26-25 - RFQ - New Elevator and Office Renovations - ÉÉ Antonine-Maillet – CSViamonde

ADDENDUM #2

PROJECT: École élémentaire Antonine-Maillet New Elevator and Office Renovations
615 Ridgeway Ave, Oshawa, Ontario L1J 2W3

ADDENDUM NO.: 2

1 ENLARGED SECOND FLOOR
A1 PLAN 1:50

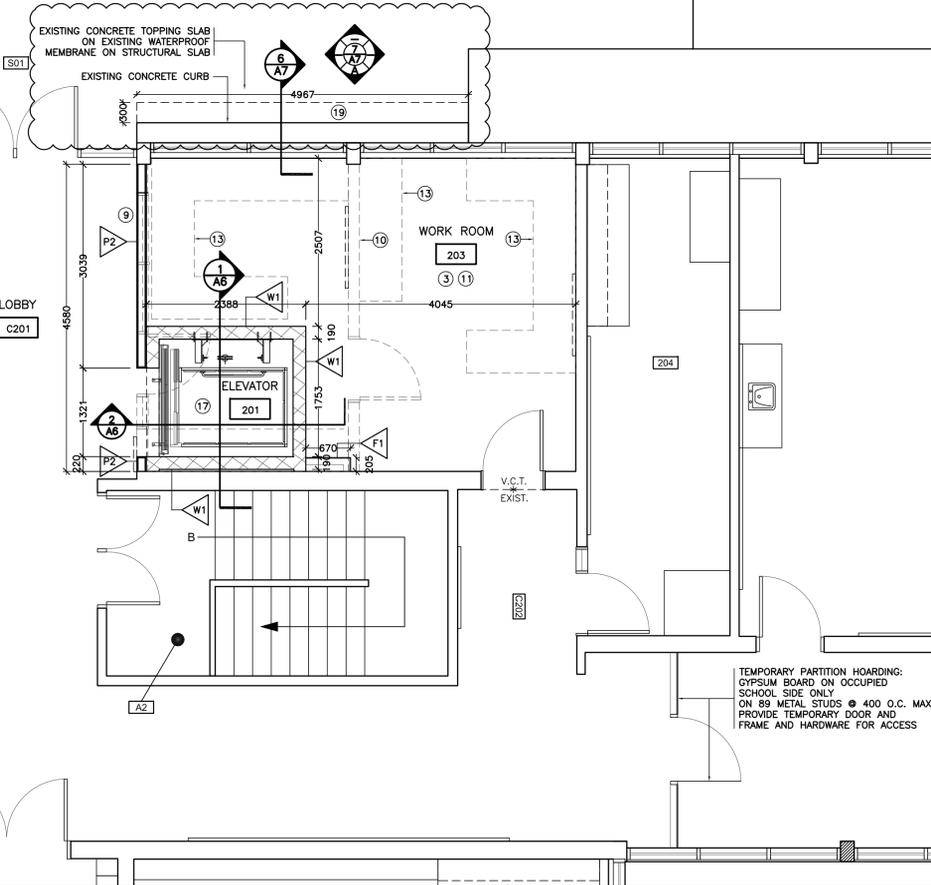
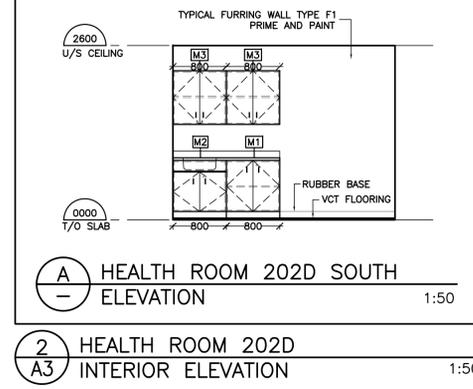
ITEM 2: ADDITIONAL FURRING WALLS AT ELECTRICAL PANEL J
REFERENCE: Drawing A3 Detail 1 revised March 18, 2026 (attached).
Drawing A5 Detail 1 revised March 18, 2026 (attached).
Drawing E-4 revised March 5, 2026 (attached).

Description: At Panel J, provide typical Furring Wall F1 similar around the panel from floor to underside of the roof deck. Locate the electrical Panel J minimum 300mm away from the corner.
Refer to Drawing A3 Detail 1 and Drawing A5 Detail 1 revised March 18, 2026 (attached), and Drawing E-4, issued by SAB Engineering Inc. revised March 5, 2026 in Addendum #2 (attached).

1 SECOND FLOOR REFLECTED CEILING PLAN
A1

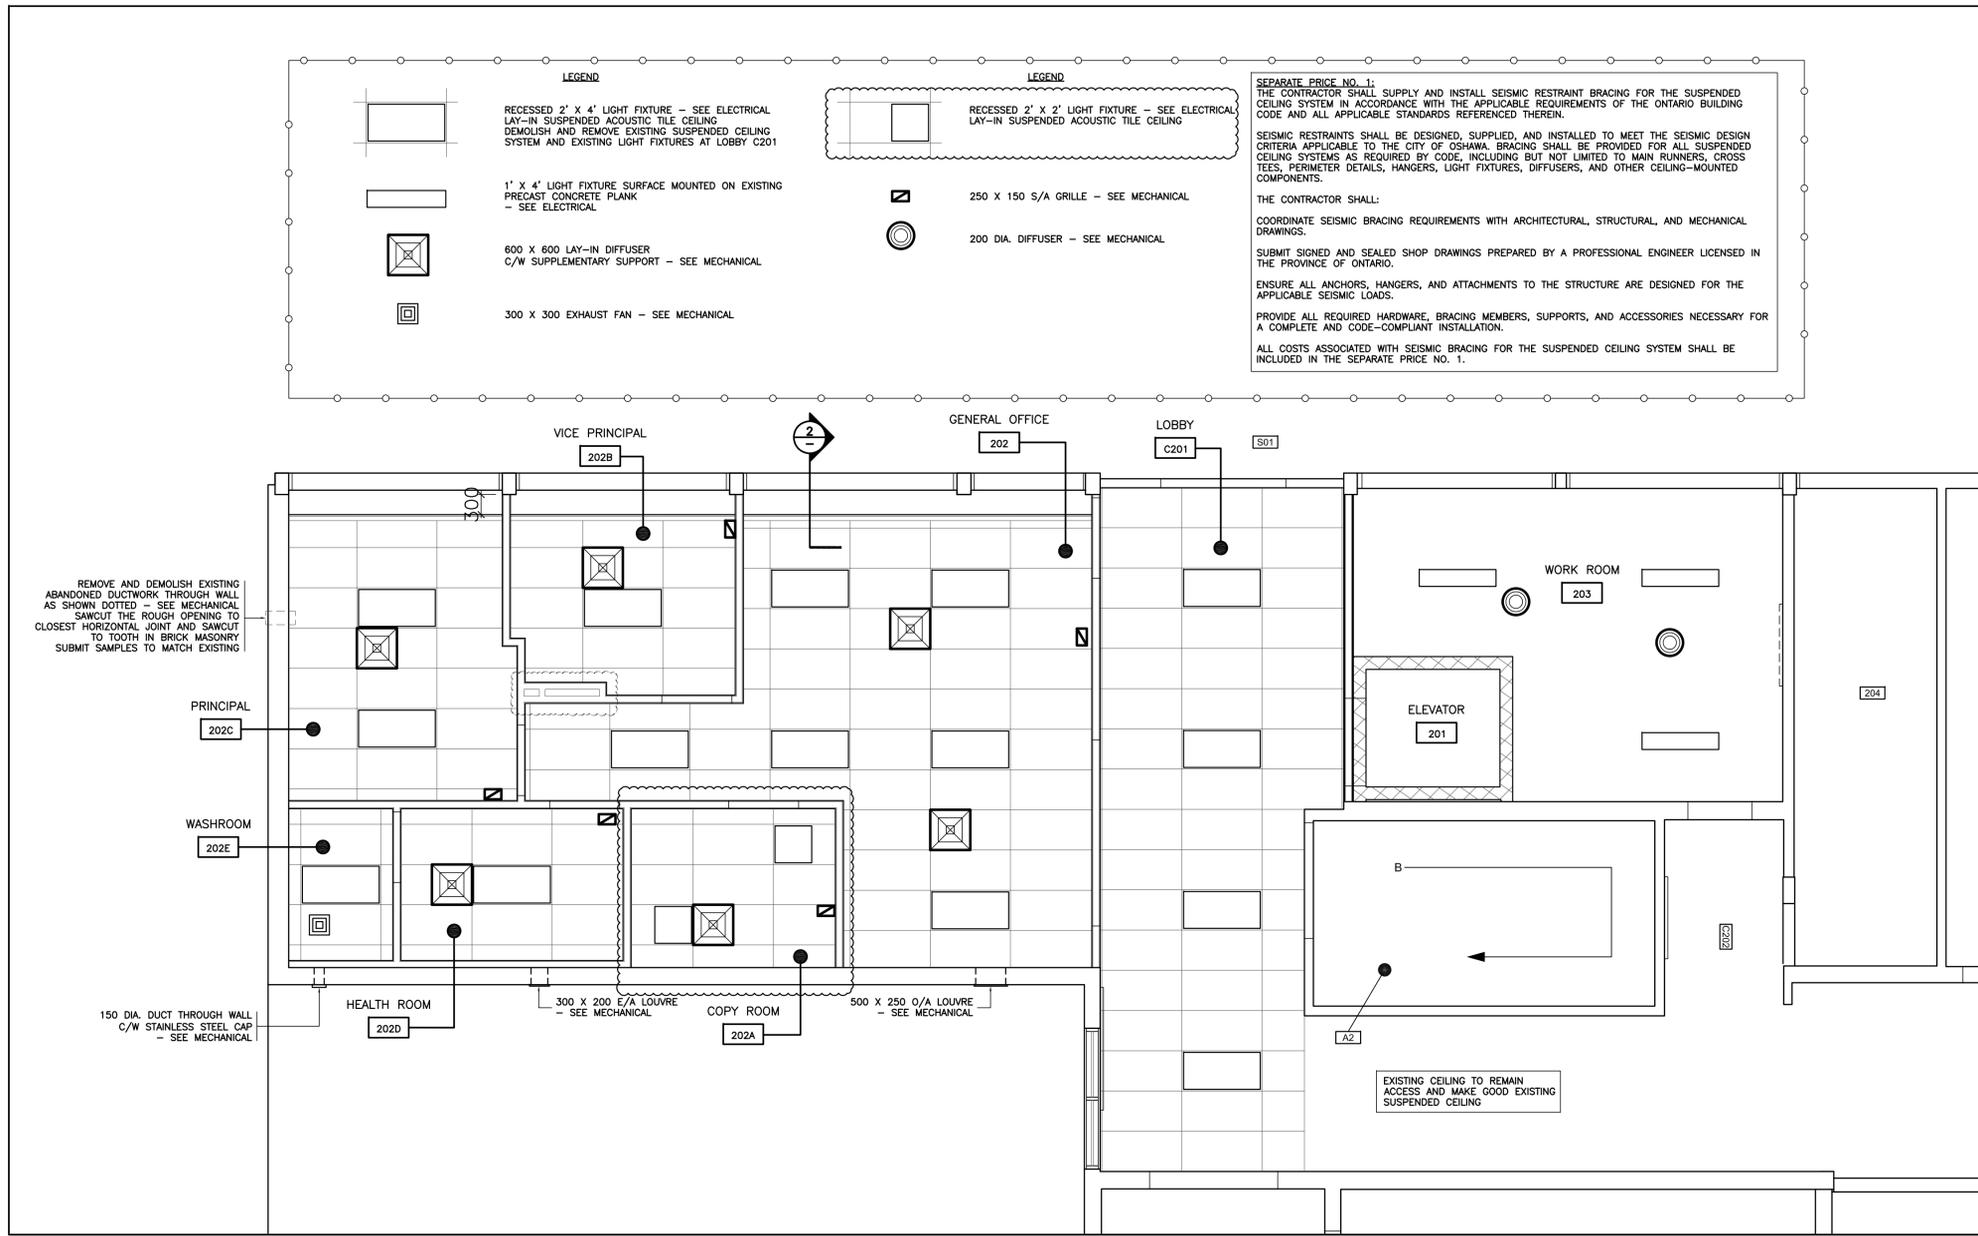
ITEM 1: REVISED CEILING LAYOUT AT COPY ROOM 202A
REFERENCE: Drawing A5 Detail 1 revised March 18, 2026 (attached).
Drawing E-3 revised March 5, 2026 (attached).

Description: At Copy Room 202A, revise 2' x 4' recessed LED light fixtures to 2' x 2' recessed LED light fixtures.
Refer to revised ceiling layout on Drawing A5 Detail 1 revised March 18, 2026 (attached), and Drawing E-3, issued by SAB Engineering Inc. revised March 5, 2026 in Addendum #2 (attached).

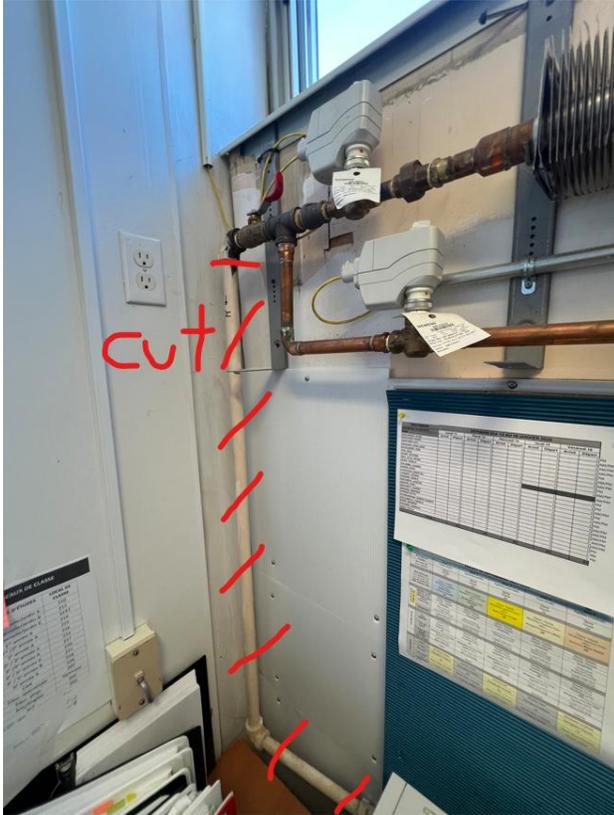
- With regards to the existing wallfin in room 201, The contractor is to cut exposed heating return pipe below elbow. Isolation valve, tee fittings, and actuators to remain. piping penetrating floor and in the ceiling space of room 101 to be removed for that line. Provide new heating return piping and connect to existing piping in the ceiling space of room 101 below and connect to existing elbow before isolation valve of ex. wallfin. Insulation for new piping to be provided. Contractor to verify size of pipe onsite prior to ordering new material. Wall-fin convector to be completely functional at the completion of work. The contractor is to provide all required accessories and materials to complete work. The contractor is to provide pipe supports as required. For new piping. The contractor is to ensure drain and refilling of hot water system is provided as required. The contractor is to ensure pipe freezing and all required pipe freezing accessories are

- Refer to the images below of piping to be removed for the wall-fin convector. The new pipping size is to match the piping size of the piping being removed.

Title:
 KEY PLAN, ELECTRICAL LEGEND AND LIGHT SCHEDULE.

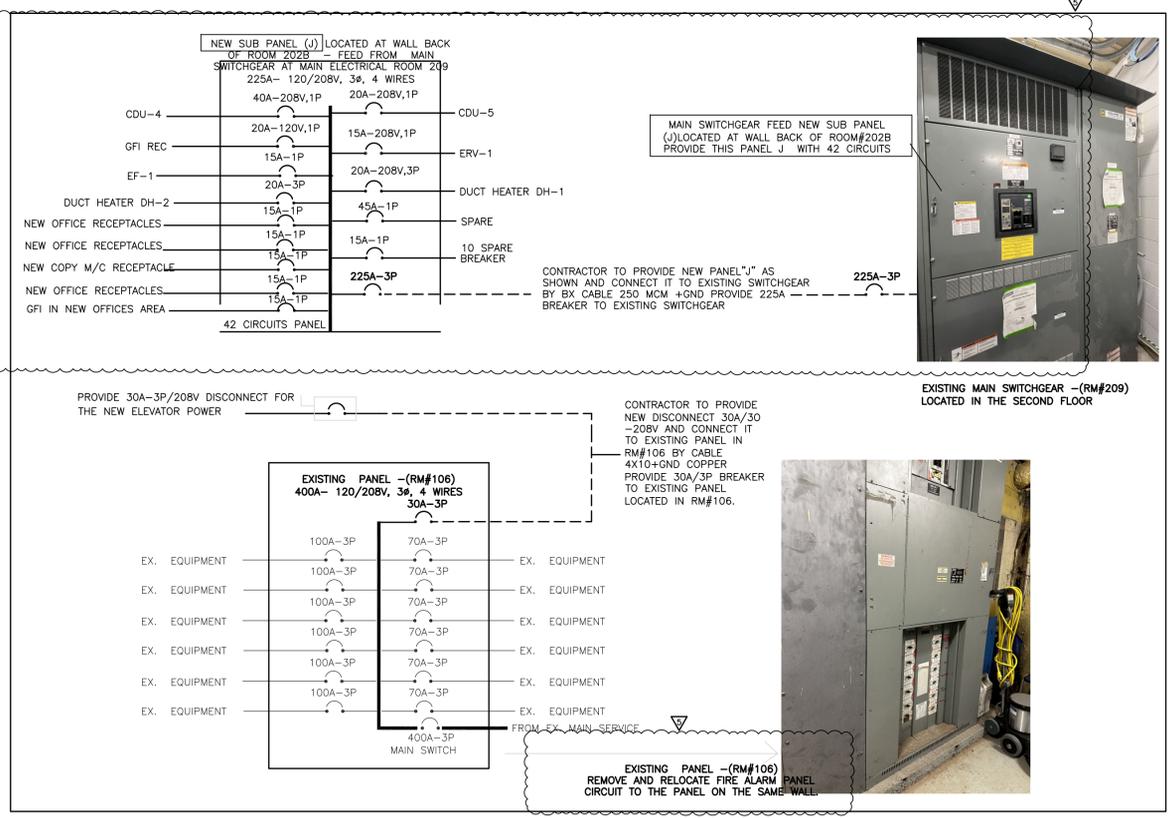
No power circuits is specified.

All power for receptacles is fed from existing panel and for the new mechanical equipment power are from the new panel (J), name of Panel (A) changed to panel(J).

Note as per updated drawing E-01, the new sub panel (J) to be provided is to be provided with 10 additional 15A spare breakers as indicated in the updated drawing.

Title:
LIGHTING CONTROL DETAILS

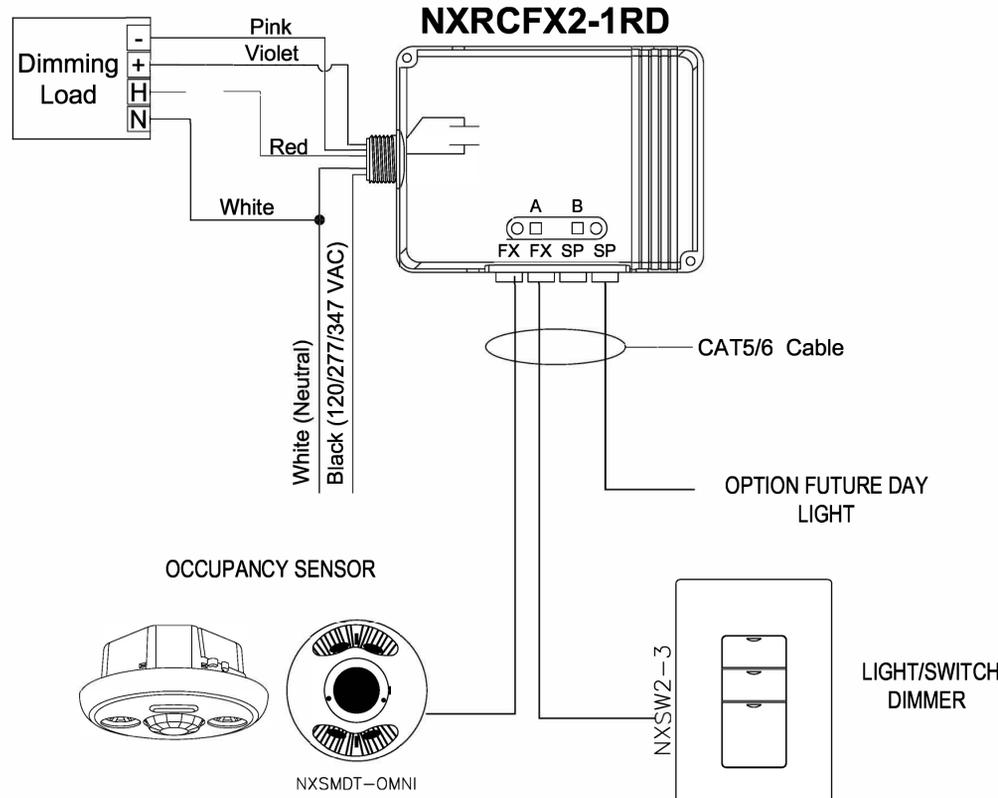
Lighting Control (E-2-1) details do not match Legend for the LVC (E-01, Wattstopper); no specification for the Dimmer Switches.

Follow Lighting control cut sheet, Model number and specifications of dimmers which in detail in the sheet E-2-1 for pricing and construction.

Title:
 GROUND & SECOND FLOORS
 POWER & SYSTEMS
 NEW WORK

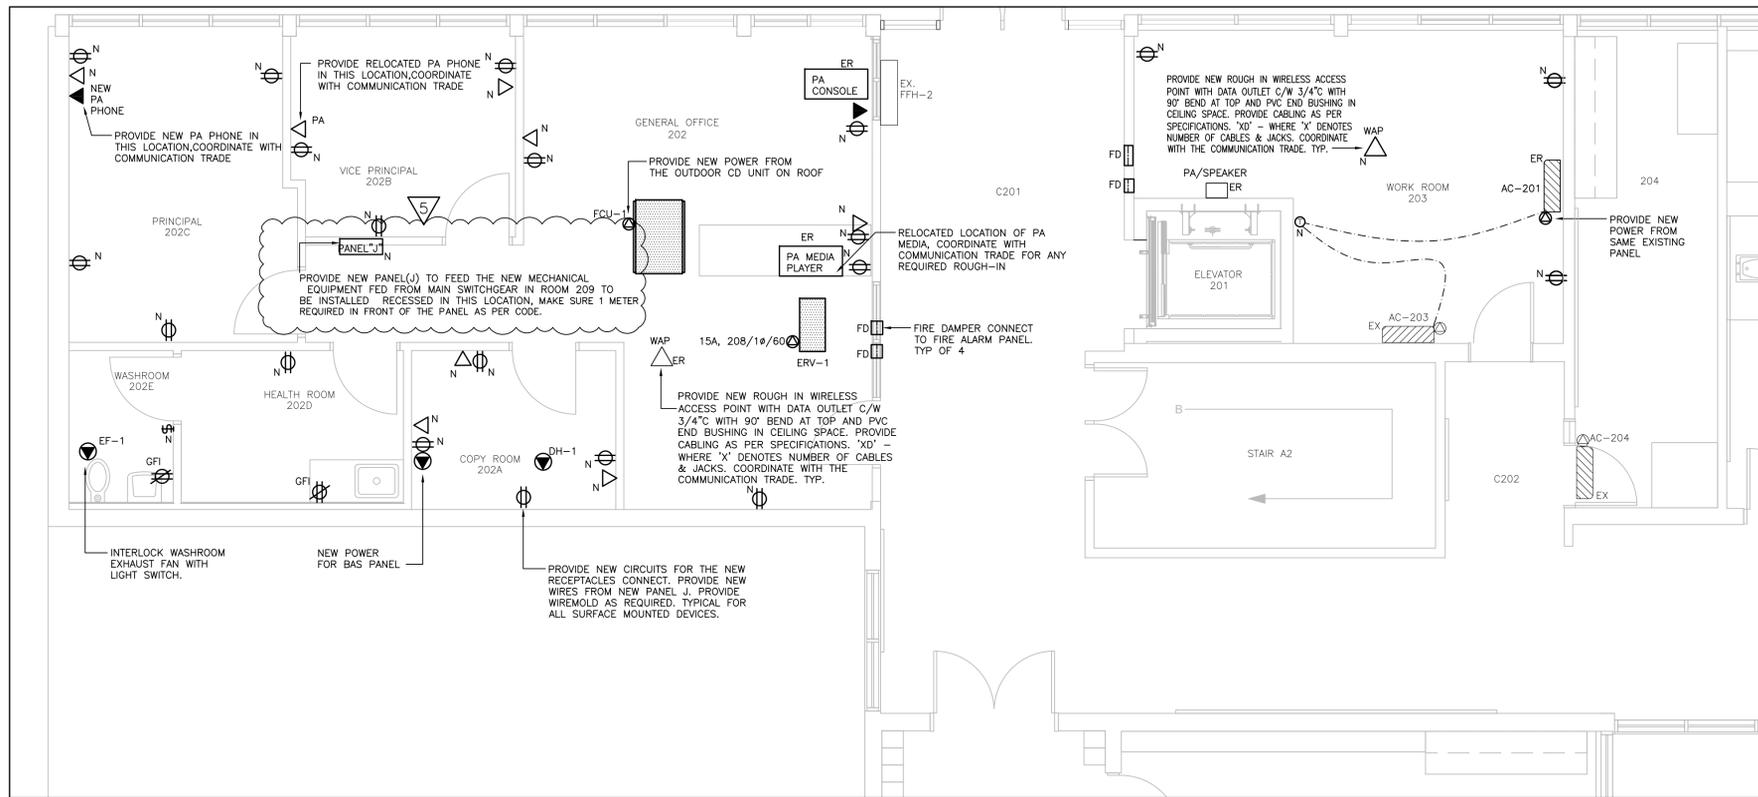
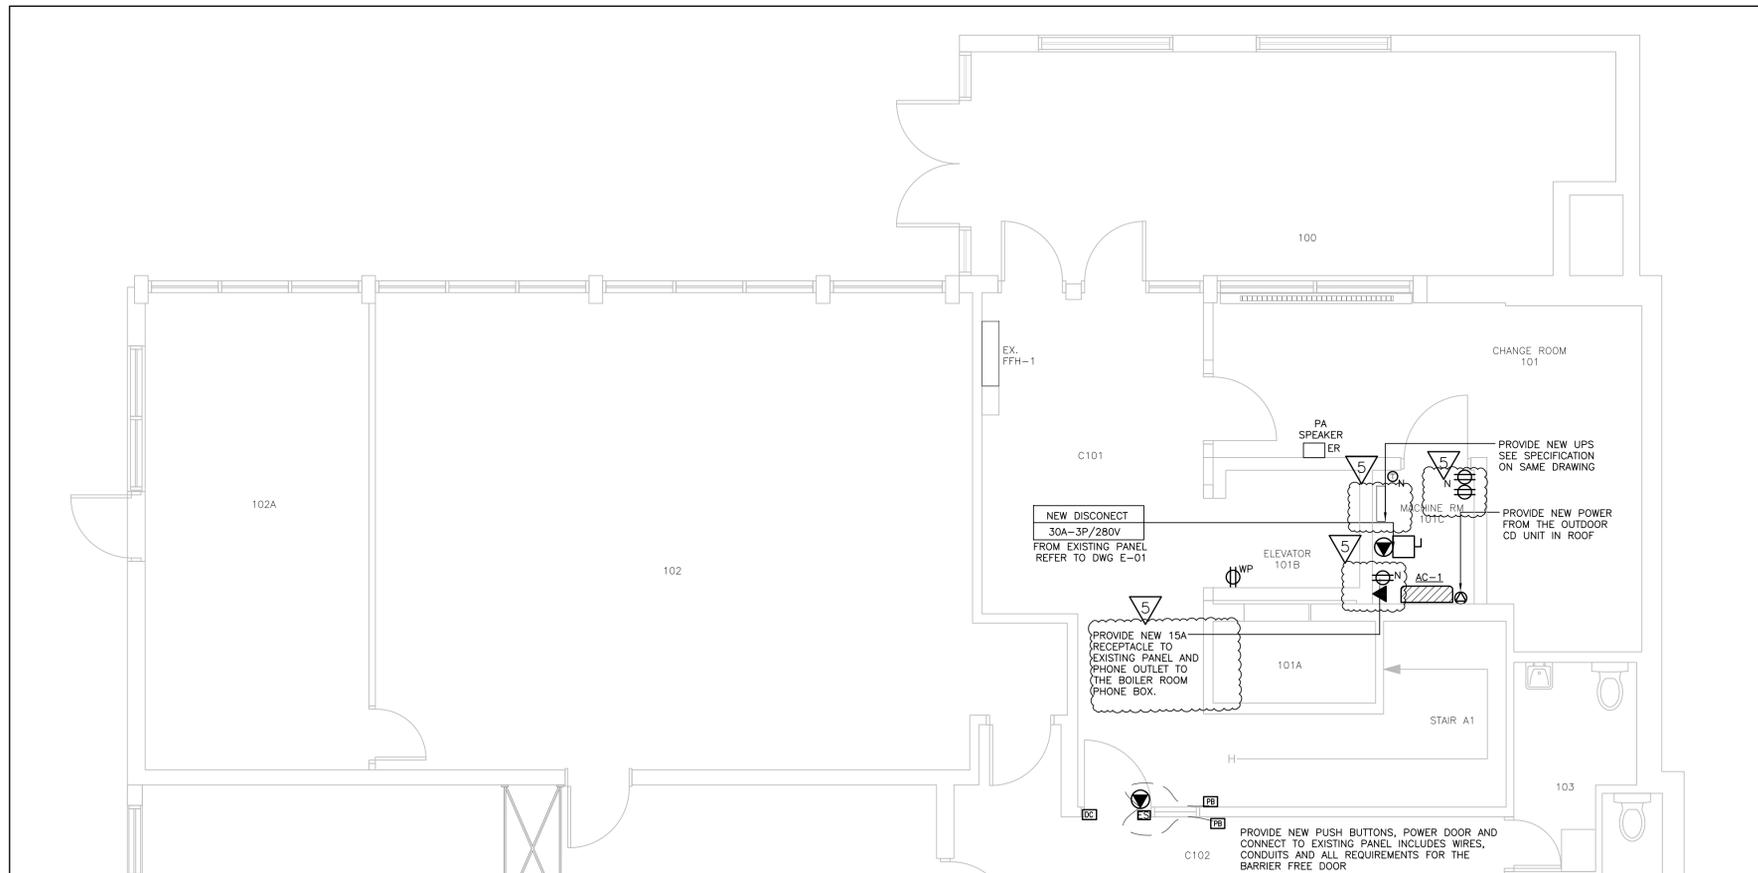
No power circuits is shown for the Door connection.

We show already Power door circuit, door strike, and door requirements are clear on sheet E-4 connect to existing panels.
